**Report: Final Report
Function: Test, Adjust, & Balance
Date: 8/24/2022**

**PROJECT
08-15 FIVE GUYS - SAVANNAH, GA**

Issue Name : SPIRAL DINING ROOM DUCT INSTALLED

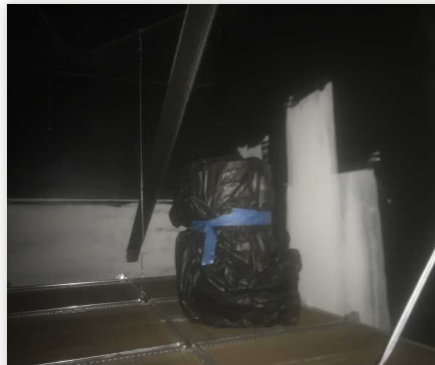
Description : SPIRAL DINING ROOM DUCT INSTALLED IS CAPPED OFF AND DOES NOT CONNECT TO ANY RTU. FOUR WAY DIFFUSERS WERE INSTALLED IN THE DROP CEILING. THIS IS DIFFERENT THEN WHAT IS SHOWN ON THE GRD.
